Americans with Disabilities Act Transition Plan

Sonoma County Community Development Commission
Sonoma County Housing Authority
1440 Guerneville Road, Santa Rosa, CA 95403-4107

Report Prepared by:

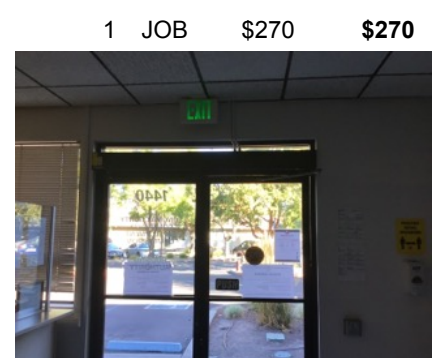
- 9 • *As-Built Description:*
Service counter (stand-up): Accessible section min. 36" length and 36" max. height (in CA: 28" to 34" high) not provided.
- *Original Description:*
Counter height is 39-5/8".
- *As-Built:* **Top: 39.5" high**
- *Proposed Solution:*
Retrofit existing counter to provide accessible section.
Interim solution: Provide auxiliary counter, table, or clipboard.

Door Clearance

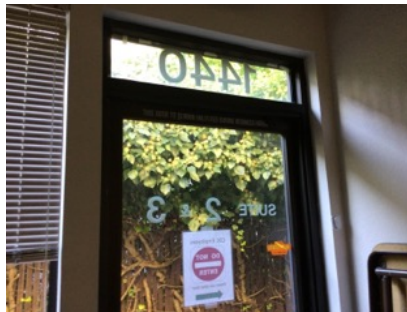
<p>17</p> <ul style="list-style-type: none"> <i>As-Built Description:</i> Door on accessible route has less than 32" clear and 80" (78" min. to closer if provided) opening width when 90° open. <i>Original Description:</i> Door width is 30" <i>As-Built:</i> 30" wide <i>Proposed Solution:</i> Provide new, larger door and frame with new accessible hardware. 	<p>ADAAG 91 4.13.5 ADA 2010 404.2.3 CBC 2007 1133B.1.1.1.1 CBC 2019 11B-404.2.3</p>	<p>1 JOB \$7,800 \$7,800</p>	
<p>Mitigated:</p> <p><input type="radio"/> YES</p> <p><input checked="" type="radio"/> NO</p>	<p>Priority 2</p> <p>Severity 3</p>

Door Swing

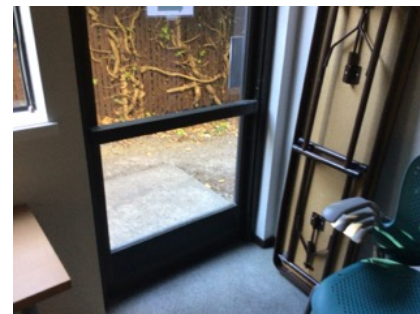
22 • *As-Built Description:*
 Front approach: At push side, door does not have clear and level maneuvering space measuring door width x 48" (door width plus 12" if door has both, latch and closer).
 • *Original Description:*
No 12" clearance on the push side beyond the latch.
 • *As-Built:* **Door width plus <12" to wall**
 • *Proposed Solution:*
 Provide relocated new door and frame; remodel walls as needed.

Signage

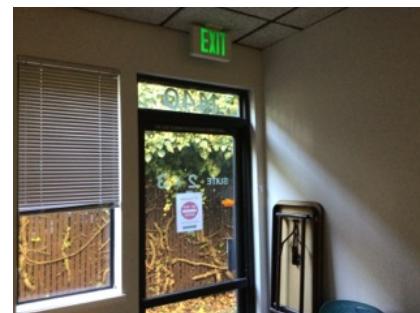
23 • *As-Built Description:*
 At final exit door to exterior: Where required exit signs are installed, signs to provide exiting information for people with vision impairment are not provided.
 • *Original Description:*
No signage (door is shown as emergency exit door on evacuation plan).
 • *Proposed Solution:*
 Provide raised letter/Braille "EXIT" sign at door.
 • **Notes:**
Optional solution is to provided signage that this is not an exit and direct neone to other exit door.

Clear Space

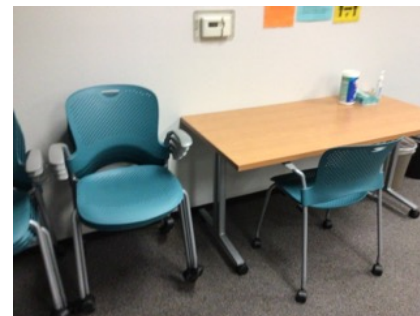
- *As-Built Description:*
Clear floor space is not 30" x 48" minimum at all switches, outlets and other controls.
- *Original Description:*
Table and stacked chairs are within clear floor space in front of thermostat.
- *Proposed Solution:*
Relocate existing furniture/obstructions.

Reach Range

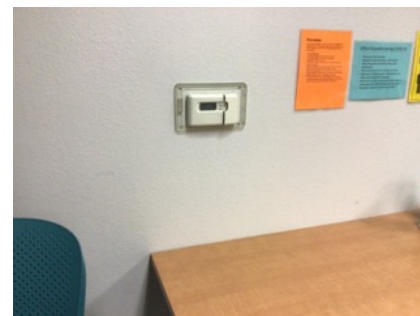
- *As-Built Description:*
Reach height to control or access point, exceeds 48" or is less than 15".
- *Original Description:*
Thermostat is out of reach range. Controls at 49" above finished floor.
- *As-Built:* **Greater than 49" high**
- *Proposed Solution:*
Modify equipment or mounting.

Reach Range

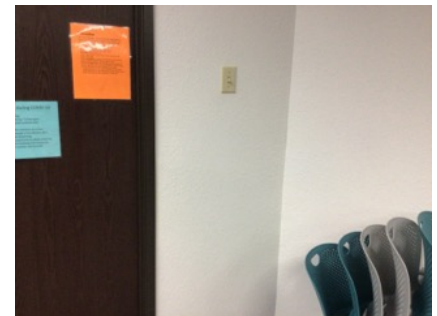
- *As-Built Description:*
Reach height to control or access point, exceeds 48" or is less than 15".
- *Original Description:*
HVAC switch is out of reach range. Controls at 49".
- *As-Built:* **49" high**
- *Proposed Solution:*
Modify equipment or mounting.

Electrical

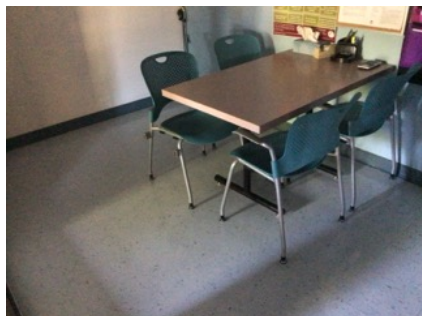
28	<ul style="list-style-type: none"> <i>As-Built Description:</i> Electric switch or control mounted less than 15" measured to the bottom of the outlet box or greater than 48 inches measured to the top of the outlet box. <i>Original Description:</i> Light switches in all Interview Rooms (a,b,c,d) are out of reach range. Top of outlet box is at 49" above finished floor. <i>As-Built:</i> 49" high to top of box <i>Proposed Solution:</i> Relocate light switches or control to between 15" and 48" height. 	ADAAG 91 4.2.5 & 6 ADA 2010 308.2.1 & CBC 2007 1117B.6.3 CBC 2019 11B-308.2.1 & 11B-308.2.2	1	JOB	\$900	\$900
		Mitigated: <input type="radio"/> YES <input checked="" type="radio"/> NO Priority 2 Severity 4

Turning Space

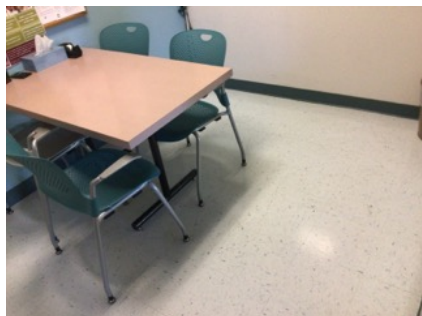
29	<ul style="list-style-type: none"> <i>As-Built Description:</i> The area does not provide a minimum 60" diameter turning space within to allow maneuvering through the space. <i>Original Description:</i> Interview rooms A & B do not provide room for 60" diameter turning radius at table. <i>Proposed Solution:</i> Modify area to provide sufficient maneuvering space. 	ADA 2010 304.3 CBC 2019 11B-304.3	1	JOB	\$1,500	\$1,500
		Mitigated: <input type="radio"/> YES <input checked="" type="radio"/> NO Priority 2 Severity 3

Reach Range

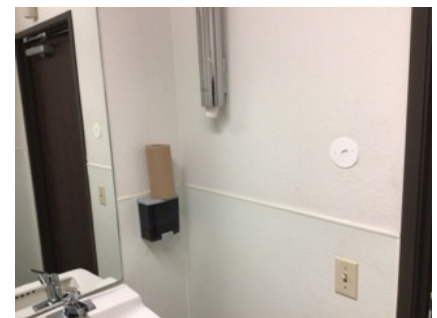
36	<ul style="list-style-type: none"> • <i>As-Built Description:</i> Reach height to control or access point, exceeds 48" or is less than 15". • <i>Original Description:</i> Cup dispenser mounted with bottom at 62" above finished floor. • <i>As-Built:</i> 62" high • <i>Proposed Solution:</i> Modify equipment or mounting. 	ADAAG 91 4.2.5	1	JOB	\$300	\$300
		ADA 2010 308.2.1				
		CBC 2007 1118B.5				
		CBC 2019 11B-308.2.1				
Mitigated: <input type="radio"/> YES <input checked="" type="radio"/> NO		Priority 2 Severity 2

Toilet Stall

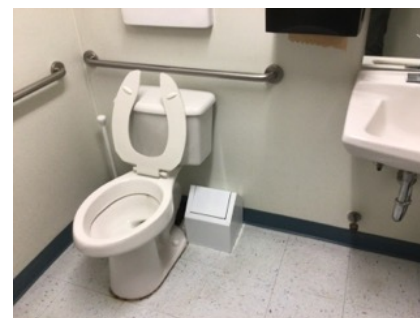
- 39 • *As-Built Description:*
60" min. clearance around a water closet measured perpendicular from the side wall not provided (Fixtures are not allowed to overlap this clearance).
- *As-Built:* **50" wide from wall to lavatory**
- *Proposed Solution:*
Remove adjacent fixture and provide new enclosure at accessible water closet.

Water Closet

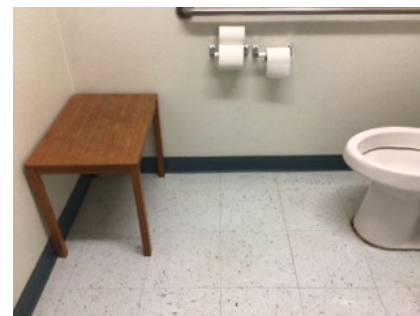
- 40 • *As-Built Description:*
CA only: In single-accommodation restroom less than 48" in front of water closet provided.
- *Original Description:*
Table in front of water closet does not allow required 48" clearance in front.
- *As-Built:* **Less than 48" in front of WC**
- *Proposed Solution:*
Remove table.

Reach Range

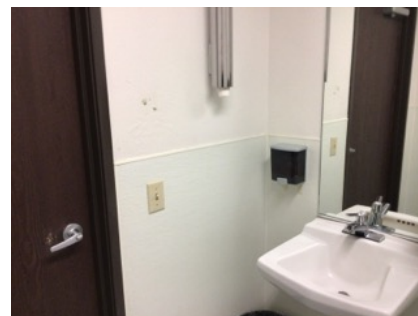
- 49
- *As-Built Description:*
Reach height to control or access point, exceeds 48" or is less than 15".
 - *Original Description:*
Cup dispenser mounted with bottom at 57-1/2" above finished floor.
 - *As-Built:* **57.5" high**
 - *Proposed Solution:*
Modify equipment or mounting.

Corridor

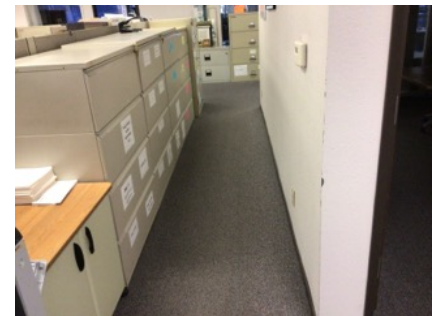
- 69 • *As-Built Description:*
Corridor less than 44" wide.
- *Original Description:*
Corridor decreases to 38" wide for a run of 14'-8".
- *As-Built:* **38" wide**
- *Proposed Solution:*
Remove or relocate furniture and storage items.

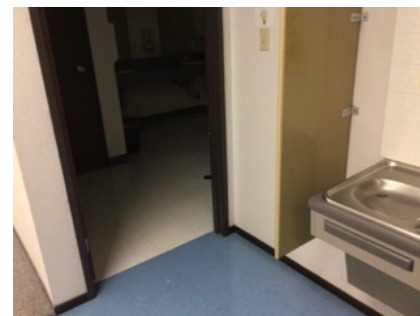
- 75
- *As-Built Description:*
Front approach: At push side, door does not have clear and level maneuvering space measuring door width x 48" (door width plus 12" if door has both, latch and closer).
 - *As-Built:* **36" from face of door to partition**
 - *Proposed Solution:*
Remove or relocate furniture or storage items.

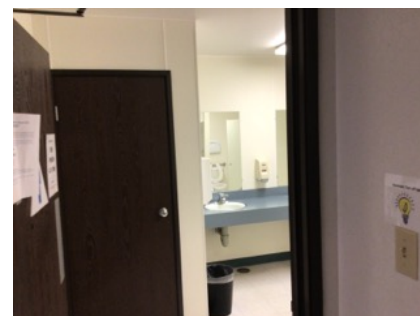
- 76
- *As-Built Description:*
Entrance to toilet or bathing facility not identified with ADAAG compliant signage.
 - *Original Description:*
Incorrect signage installed.
 - *Proposed Solution:*
Provide ADA compliant sign mounted at 48" min. above to baseline of the lowest Braille cells and 60" max. to baseline of the highest line of raised characters on nearest adjacent wall, on latch side of a single door (located not to cause a Braille reader to stand within the door swing).

Stall Door

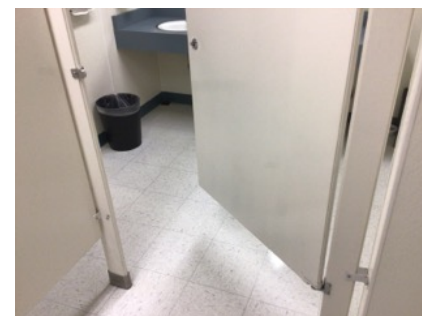
- 78 • *As-Built Description:*
Stall door to accessible compartment not self closing.
- *Original Description:*
Self-closing mechanism is not working properly and door handles are not present.
- *Proposed Solution:*
Adjust closer.

Wheelchair Clearance

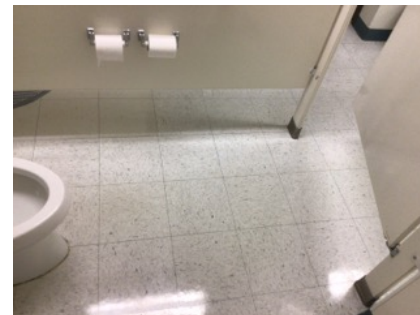
81	<ul style="list-style-type: none"> As-Built Description: CA only: Minimum space in front of accessible compartment stall less than 48" clear, perpendicular to door. Original Description: Water closet only has 45-1/2" clearance in front. As-Built: 45.5" in front of WC Proposed Solution: Relocate or reconfigure accessible compartment stall to provide 48" clear in front, or provide new stall. 	<p>CBC 2007 1115B.3.1.4.3</p> <p>CBC 2019 11B-604.3.1</p>	1	JOB	\$4,500	\$4,500
		<p>Mitigated: <input type="radio"/> YES <input checked="" type="radio"/> NO</p> <p>Priority 3</p> <p>Severity 4</p>

Door Swing

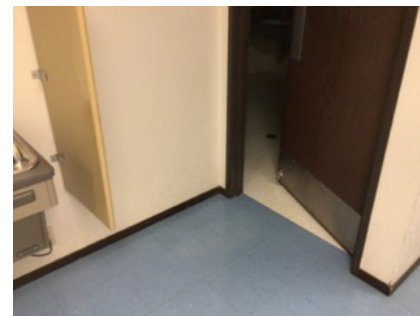
- 90 • *As-Built Description:*
Front approach: At push side, door does not have clear and level maneuvering space measuring door width x 48" (door width plus 12" if door has both, latch and closer).
- *As-Built:* **43" from face of door to partition**
- *Proposed Solution:*
Remove or relocate furniture or storage items.

Signage

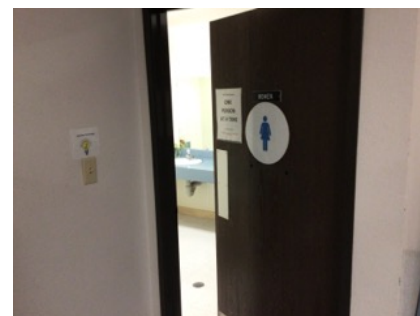
- 91 • *As-Built Description:*
Entrance to toilet or bathing facility not identified with ADAAG compliant signage.
- *Original Description:*
Incorrect signage installed.
- *Proposed Solution:*
Provide ADA compliant sign mounted at 48" min. above to baseline of the lowest Braille cells and 60" max. to baseline of the highest line of raised characters on nearest adjacent wall, on latch side of a single door (located not to cause a Braille reader to stand within the door swing).

Water Closet

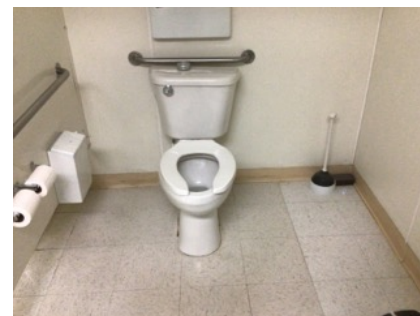
- 92 • *As-Built Description:*
Water closet not 16"-18" (CA: 17"-18") from near side wall to center line of water closet (2010 ADAAG: 16"-18").
- *Original Description:*
Centerline of water closet is 26" from side wall.
- *As-Built:* **26" o.c.**
- *Proposed Solution:*
Relocate existing water closet and plumbing, remount with offset closet flange to provide 18" max. from side wall.

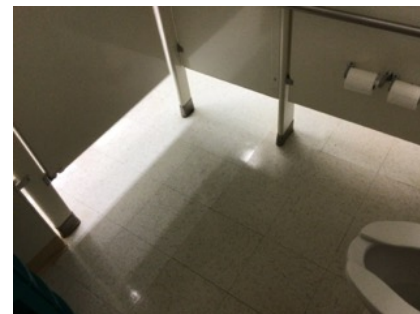
• *Original Description:*
Water closet only has 47-1/2" clearance in front.

• *As-Built:* **47.5" in front of WC**

• *Proposed Solution:*
Relocate or reconfigure accessible compartment stall to provide 48" clear in front, or provide new stall.
